## ■ DOOR LOCK CONTROL SYSTEM

229LC156

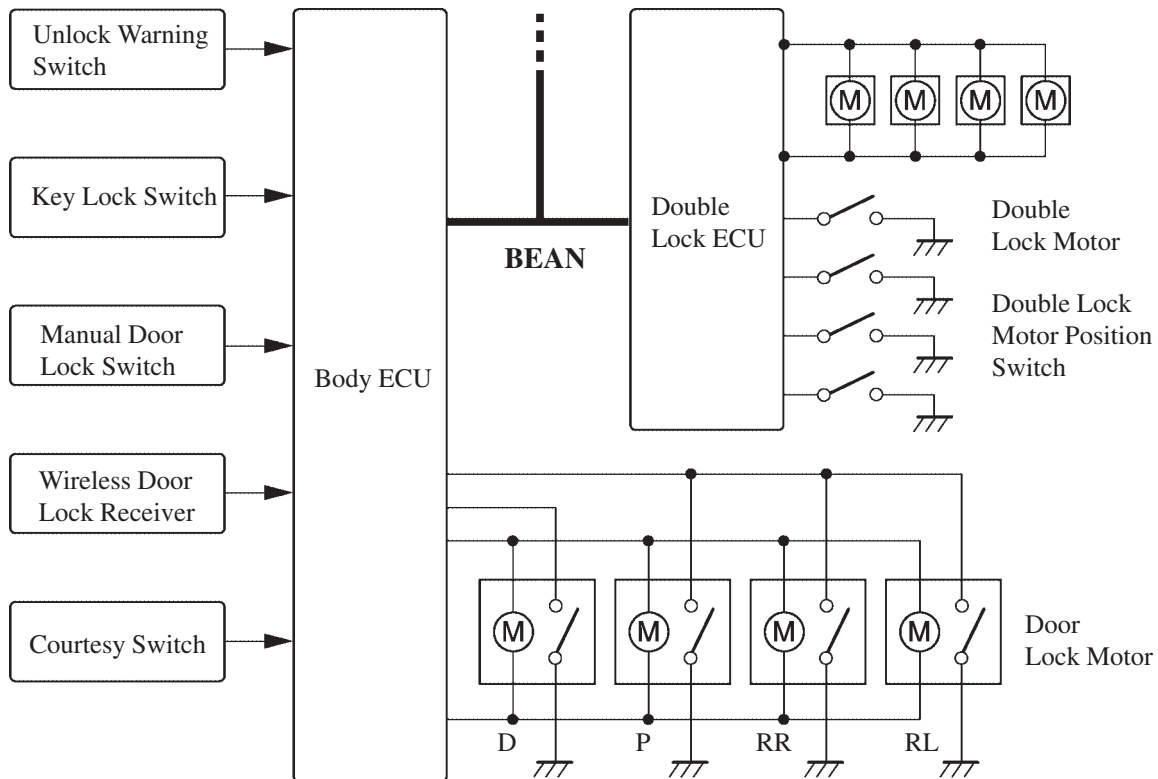
- For improved theft deterrence performance, a double locking system has been added as standard equipment on the RHD models for Europe and optional equipment on the LHD models for Europe.
- The double lock ECU communicates with the body ECU.
- The double locking system has the following functions.:
  - 1) The double locking system also prevents the doors from being opened through the operation of the inside door knobs. Thus, the doors cannot be opened either from the inside or the outside of the vehicle.
  - 2) To lock the doors with this system, pressing the transmitter's LOCK switch, then pressing it again within 5 seconds activates the double locking system.
  - 3) However, as an emergency unlocking maneuver, the driver's and passenger's door can be unlocked with key.
